CDM: Recommendation Form for Small Scale Methodologies (version 01)

Date of SSC WG meeting:	10–12 November 2008, SSC WG 18
Title/Subject (give a small title or specify the subject of your submission, maximum 200 characters):	Clarification regarding the interpretation of grid import and determining baseline emission factor in AMS-I.C
Indicative methodology to which your submission relates (refer the items of Appendix B of the Simplified Modalities and Procedures), if applicable.	AMS-I.C
Name of the authors of the query:	Bhawna Singh Institution: Agrinergy Consultancy Private Limited bhawna.singh@agrinergy.com

Information to be completed by the secretariat	
SSC-Submission number	SSC_229
Date when the form was received at UNFCCC secretariat	12 November 2008
Date of transmission to the EB	12 November 2008
Date of posting in the UNFCCC CDM web site	12 November 2008

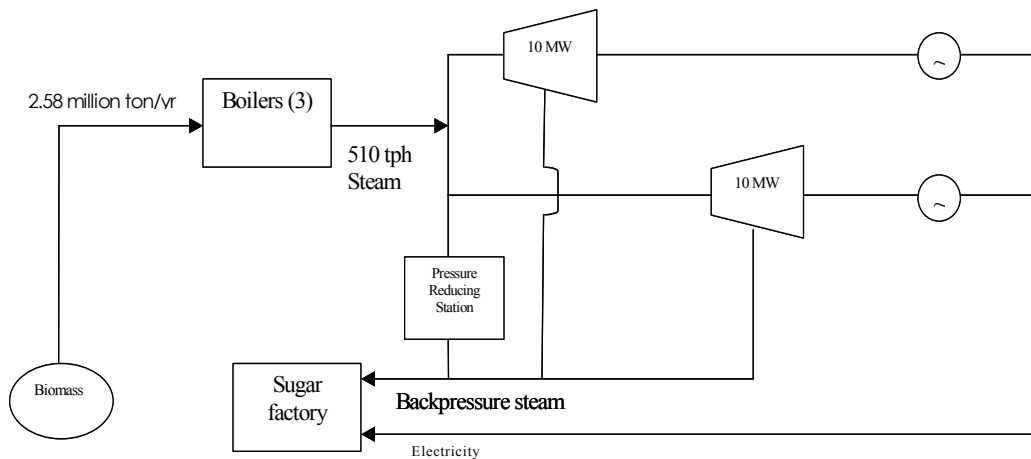
Intuitively one would assume that the CEF to be applied would be the grid CEF as this represents the emissions of the baseline electricity that is being displaced. The problem arises in the interpretation of grid import and the clarification relates primarily to this. In the text above the import of electricity could be interpreted as only import to the site at which the project activity takes place and not general import by third parties on the grid. However it should be noted that the electricity supplied by the project activity replaces electricity imported by third parties from the grid. The issue in applying paragraph 11 is that the

existing captive plant is greater in capacity than the project activity and therefore “the emission factor shall be calculated as the weighted average of captive electricity generation and the net grid import”.

Regarding the question about the emission factor to be used (grid or captive power plant), it should be noted that additional information would be needed. However, if the Project Proponent can demonstrate that the electricity supplied by the project activity replaces electricity imported from the grid, the emission factor of the grid could be used.

Diagrammatic representation of the baseline and project activity

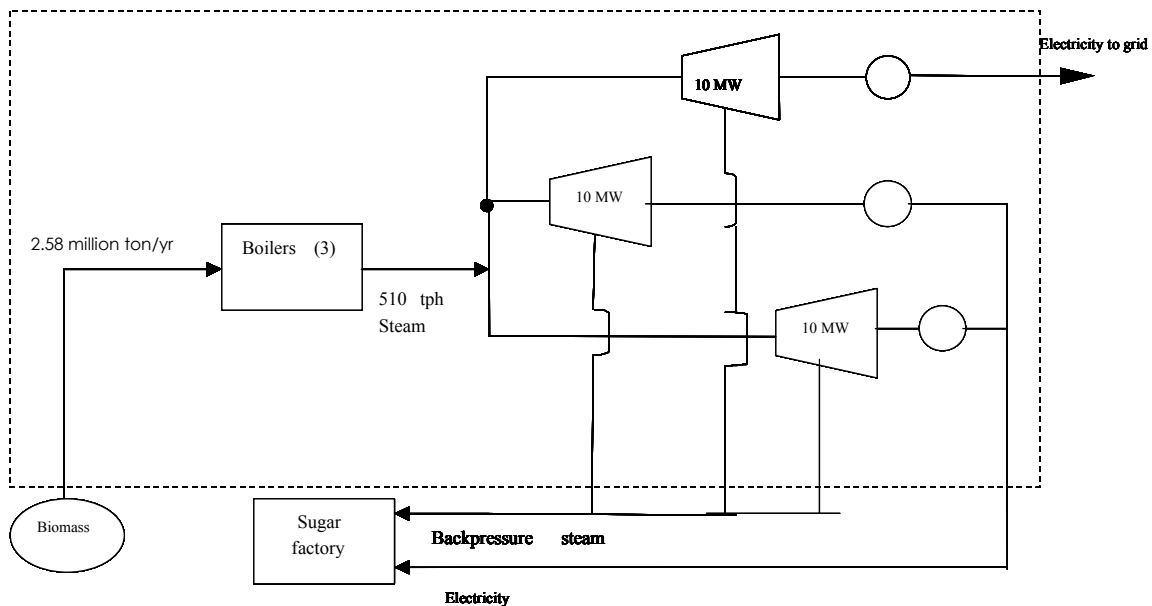
The project activity will add a turbine generator to a steam source, the steam would be generated in the baseline scenario and there is no change in the steam output resulting from the project activity (relative to the baseline scenario). Through the addition of the turbine generator the project activity will supply electricity to the grid. The baseline is the existing power plant that meets the captive electricity demand of the adjacent sugar plant through the generation of heat and electricity through the combustion of renewable biomass. The project activity is proposed under baseline scenario 7 (e) of AMS IC version 13.

1. If we assume that import only refers to the plant site then we determine the CEF based on the captive generation CEF (as imports to the site have historically been zero). As the captive generation is from renewable biomass the CEF for grid exports becomes zero
2. If we assume that import refers to the plant site and the grid in general and determine the CEF on the basis of the weighted average. As the captive generation in our project is twice that of the project activity generation the CEF is therefore $(0.66 \times \text{captive CEF} + 0.33 \text{ grid CEF})$, i.e. one third of the grid CEF.
3. The final alternative is to apply the grid CEF, which would seem the most relevant and applicable choice.

We would therefore be interested to seek a clarification on how the CEF should be calculated?

The SSC WG agreed to clarify that the described project activity is not eligible to apply AMS-I.C.

The important attribute of AMS-I.C is that the project activity shall displace fossil fuel based energy production with renewable energy. For cogeneration project activity, AMS-I.C states "Cogeneration projects that displace/ avoid fossil fuel consumption in the production of thermal energy (e.g. steam or process heat) and/or electricity shall use this methodology". The interpretation of paragraph 7 (e) of AMS-I.C version 13 is that electricity is imported from the grid and/or produced in an on-site captive power plant using fossil fuels (with a possibility of export to the grid); steam/heat is produced from renewable biomass. As this is not the situation described in the project activity and it is merely the addition of steam turbine to the existing steam source, AMS-I.C is not applicable to the project activity.

The SSC WG noted from the submission that the project activity involves the generation of steam using a biomass residue as a fuel and the surplus steam is used to drive a turbine-generator to produce electricity, which is then supplied to the grid. The project activity, which involves the addition of turbine-generator in already existing steam source, cannot be considered as a cogeneration plant. The baseline for this project includes the possible scenarios for adding additional generation to the grid rather than generation of power within the boundary or generation of power at consumer sites outside the boundary.

The SSC WG also noted that the use of a pressure-reducing device in the baseline shows that it has surplus steam energy in the baseline. The author of the submission may wish to explore: (a) AMS-III.Q for project activity utilizing waste pressure to generate electricity that will be supplied to grid, **or** (b) AMS-I.D for renewable based electricity generation displacing grid.
